## EXTRAORDINARY LOCAL TRAFFIC COMMITTEE MEETING

## REPORT OF THE EXTRAORDINARY LOCAL TRAFFIC COMMITTEE MEETING HELD ON WEDNESDAY, 27 JANUARY 2021

File No: I2021/73

Figure 1 – location of requested yellow lines.

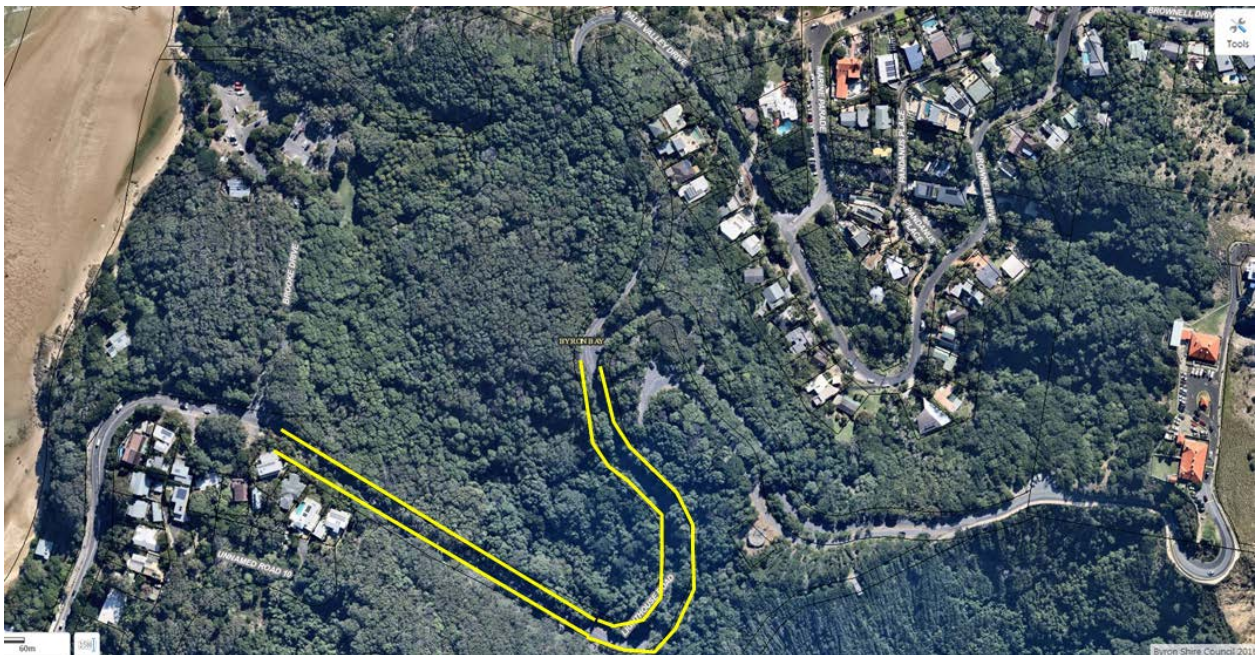
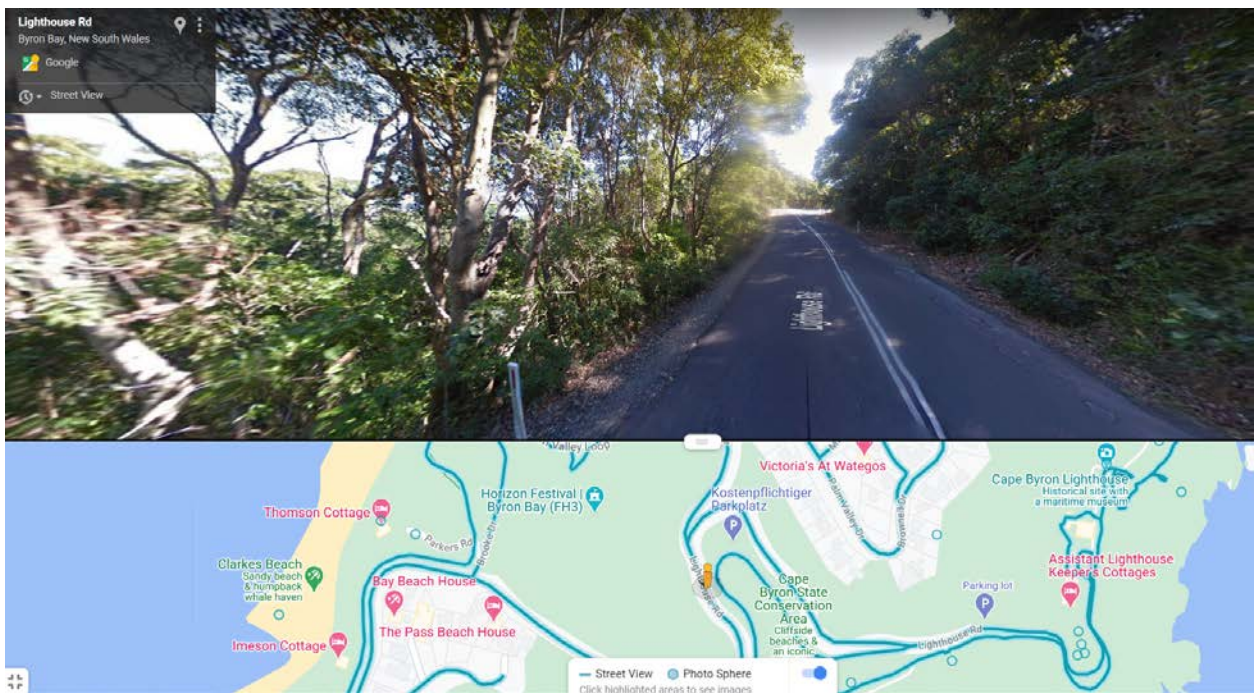
Kehoe: Not enough shoulder width for safe pedestrian access, a boardwalk would be required to provide adequate separation of pedestrians from vehicles. Do you have statistics on parking infringements in that area? Anecdotally, Police are not seeing a lot of cars parked in this area.

Cameron: Do pedestrians walk on the gravel shoulder or road?

Kehoe: Any directional signage to direct pedestrians away from this section?

**That Council endorse the installation of yellow lines along Lighthouse Road from the Brooke Drive intersection extending through to the start of Palm Valley Drive.**

Refer to the image below for its location circled in blue.

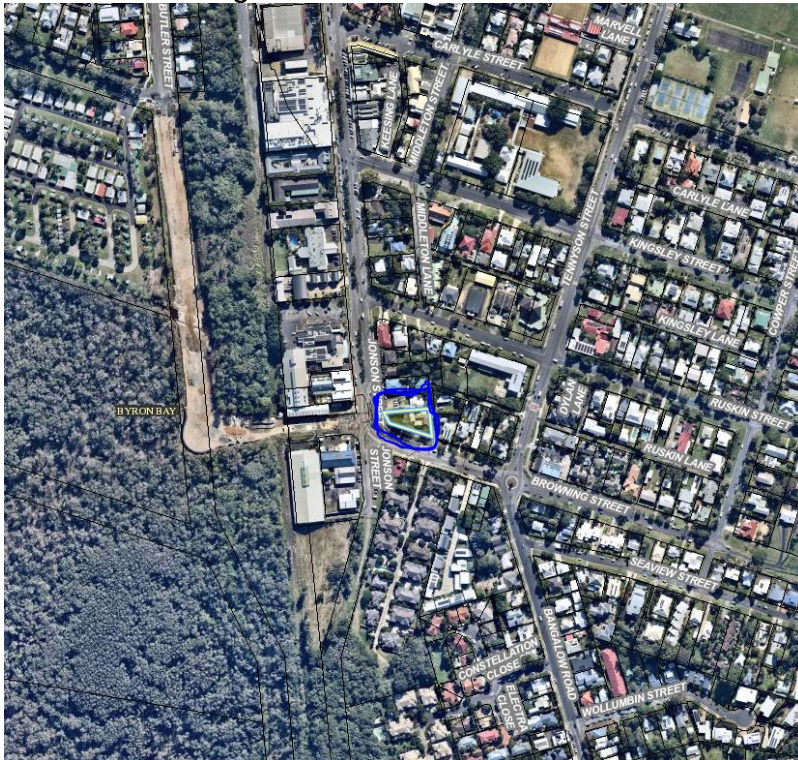
Clarification of the Give Way signs – are they for the shared path? yes

Cameron: The shared path should have the priority. Is there an issue if the laneway does not have priority?

Shanahan: Pedestrian pathways have to give way to public road.

Pearce: Island coming out of Ruskin lane could be widened.

Shanahan: Median on Browning St should be 900mm wide.

Flockton: The development engineers to ensure the angle of the “A” size Give Way signage is appropriate and directed towards cyclists/pedestrians.

**That Council approve the regulatory signage shown in Attachment 1 (E2020/95011) which is associated with development application 10.2019.616.1 and Roads Act application 51.2019.616.2.**
